STAFF REPORT MEETING OF:	RE:	Brighton at Winslow
	Plan:	SP-36-1-21
	Municipality:	Winslow Twp.
	Applicant:	SJS Winslow, LLC
	Abuts County Route:	Sicklerville Rd. (Cr. 705)

**CAMDEN COUNTY PLANNING BOARD
COUNTY ENGINEER'S REVIEW
OF SUBDIVISIONS AND
SITE DEVELOPMENT PLANS**

**COUNTY PLAN:
SP-36-1-21**

Brighton at Winslow
PROJECT NAME

OVERALL SITE PLAN

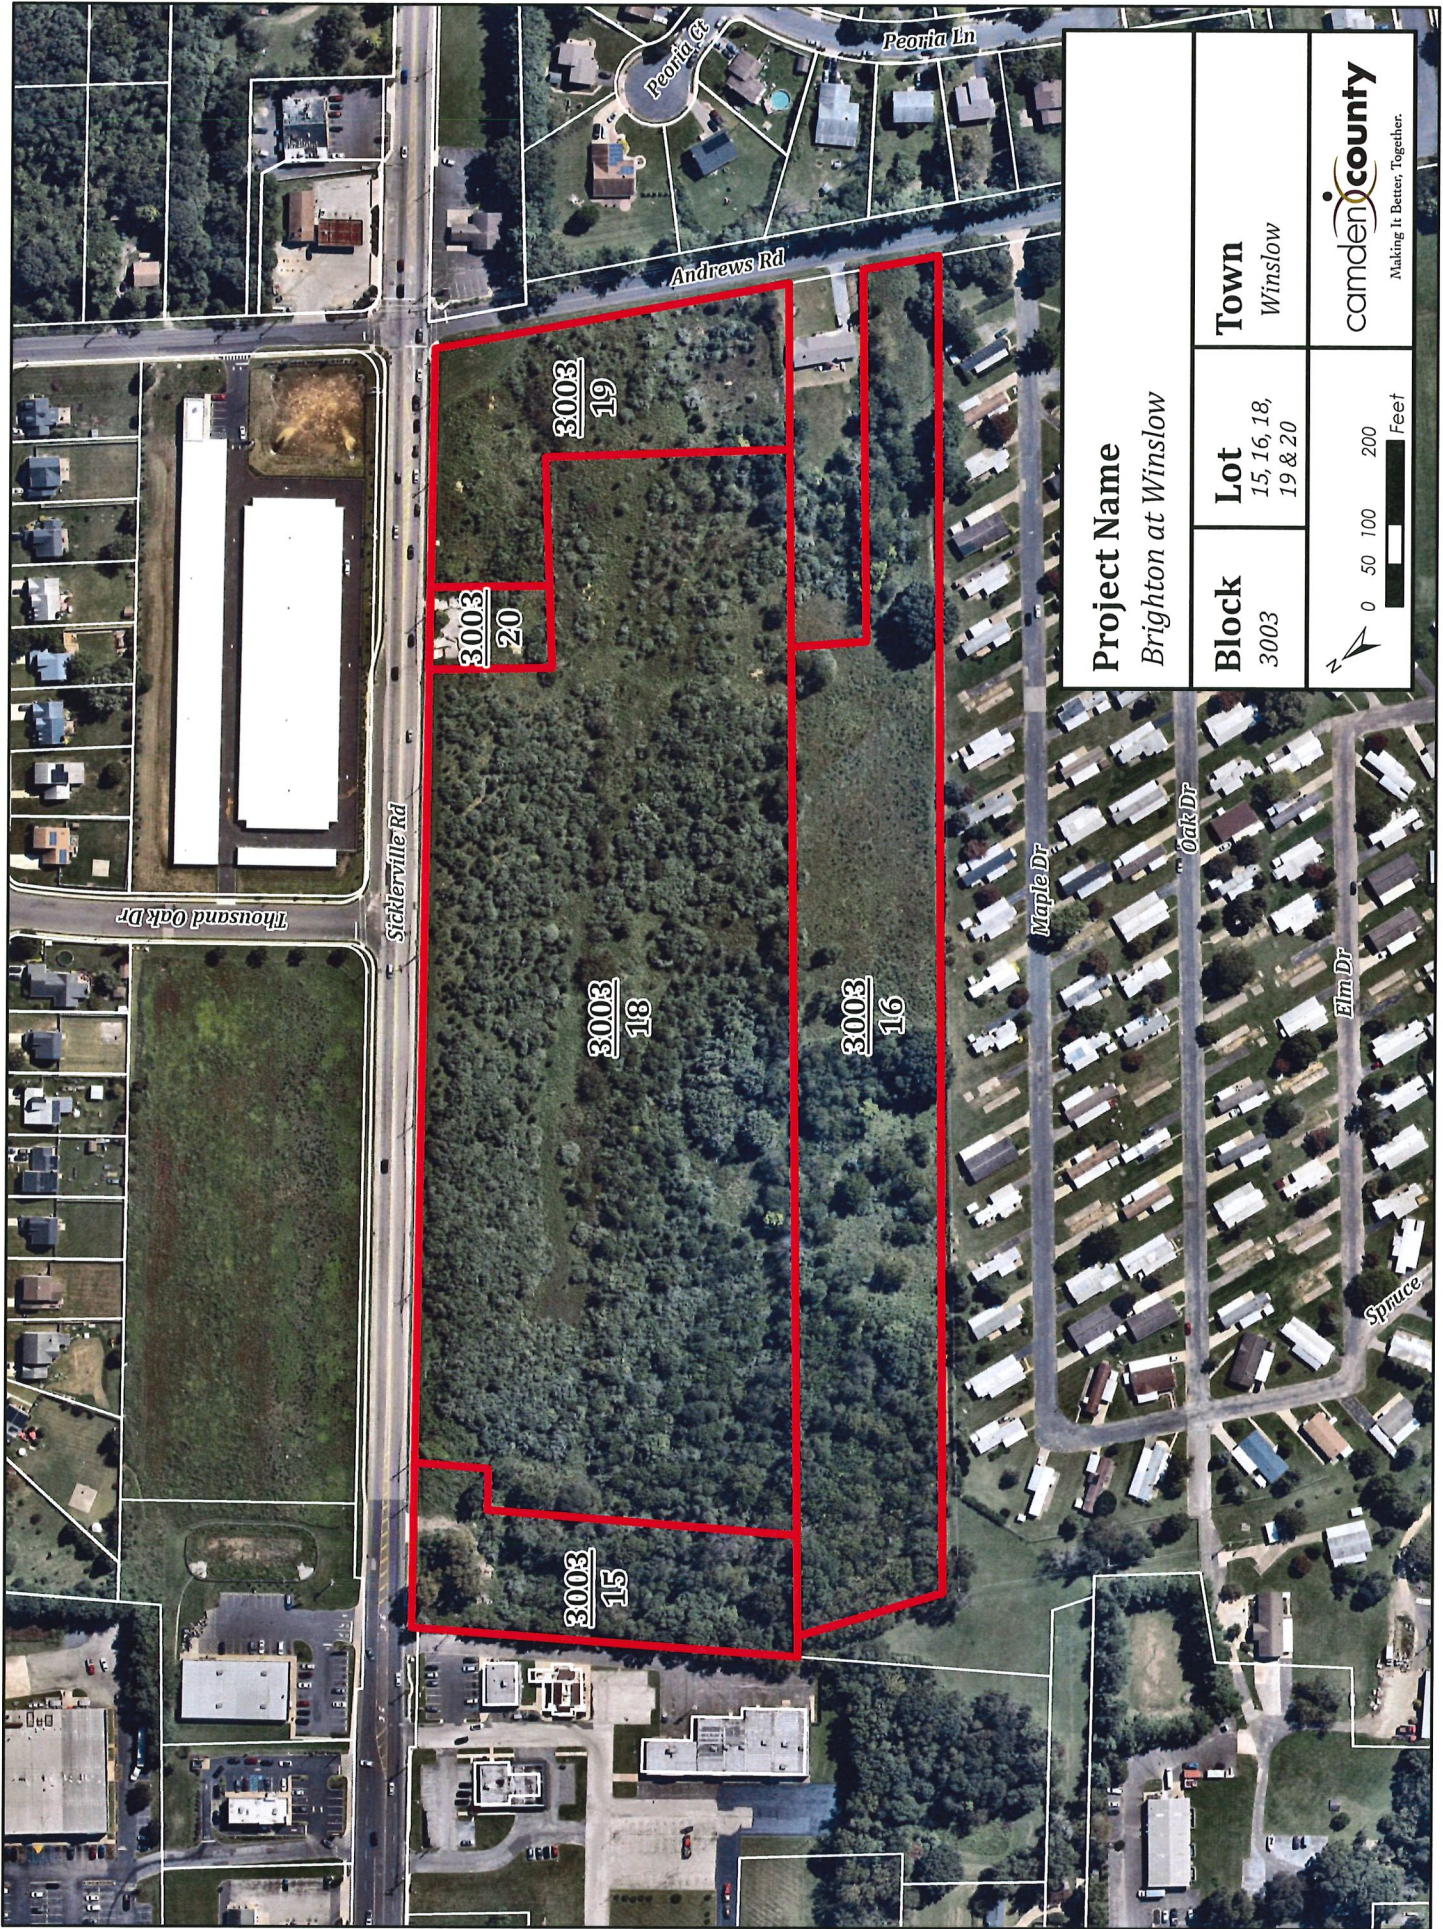
1. The plans should include a note indicating "All sidewalk and curb within the County right-of-way along the property frontage that is deteriorated or presents a tripping hazard shall be replaced under the direction of the County Engineer or his/her representative."

2. The sight triangles indicated on the plans should be revised to reflect a distance of 500 feet in each direction for the movement turning left out of Driveway 1.

3. The inlets along the site frontage lack bicycle-safe grates and Type 'N-Eco' curb pieces. Additionally, the asphalt along several inlets has settled, indicating a need for these inlets to be reconstructed. The plans should be revised to indicate the reconstruction of these inlets, as deemed necessary by the County Engineer or his/her representative, with new bicycle-safe grates and Type 'N-Eco' curb pieces.

4. The plans indicate the existing "B" inlet at the full-movement site access is to remain in the driveway ingress and is to be retrofitted with an alternate backplate to accommodate traffic

rolling over the inlet. This configuration is not acceptable, since the inlet may receive a significant amount of traffic impact and require excessive maintenance. The inlet should be replaced with a new inlet along the curb. A new cross-drain pipe should be constructed to connect it to the existing storm drainage inlet across Sicklerville Road (CR 705). The existing cross-drain pipe should be filled with controlled low-strength material (CLSM) in accordance with NJDOT specifications. The downstream inlet should be reconstructed with new bicycle-safe grate and Type-N eco curb piece as needed. The plans should be updated accordingly, and the SWM report should be revised to analyze the drainage modifications.

5. The driveway aprons and depressed curb along Sicklerville Road (CR 705) near the northwestern corner of the site should be removed and replaced with full-reveal curb.

6. Truck turning exhibits should be provided for the driveway accesses along Sicklerville Road (CR 705) to ensure the expected delivery and emergency vehicles can be accommodated without encroaching on the proposed concrete islands.

7. A detail for the proposed islands should be provided, incorporating NJDOT standard, mountable 12" X 13" Concrete Sloping Curb and 6" thick, reinforced concrete in accordance with the County Standard for concrete driveways and aprons.

8. The proposed curb ramp along the north side of Sicklerville Road (CR 705) appears to conflict with the drainage inlet in this location. The plans should be revised accordingly.

9. The asphalt pavement condition along Sicklerville Road (CR 705) is in poor condition and is not expected to support the required striping eradication, RPM removal, pavement marking installation and RPM installation. The full pavement width should be milled and overlaid along the site frontage, spanning the length of striping modifications, drainage improvements and other proposed pavement disturbance.

10. Two-way center turn lane signs (R3-9b), with "BEGIN" (R3-9cP) and "END" (R3-9dP) plaques should be installed along either approach to the terminus of the extended two-way center turn lane.

11. The 10' long broken yellow line with 30' gaps along the two-way center turn lane should be identified in the pavement marking legend.
12. NO LEFT TURN (R3-2) signs should be added along the westbound Sicklerville Road (CR 705) approach to the right-in, right-out driveway in accordance with County Standard Detail 12.

13. The double yellow lines along the bay tapers approaching the left turn lanes are to use reverse curves with minimum radii of 75' in accordance with County Standard Detail 14, rather than straight-line tapers.

14. Traffic control plans should be provided in accordance with 2.2.6.
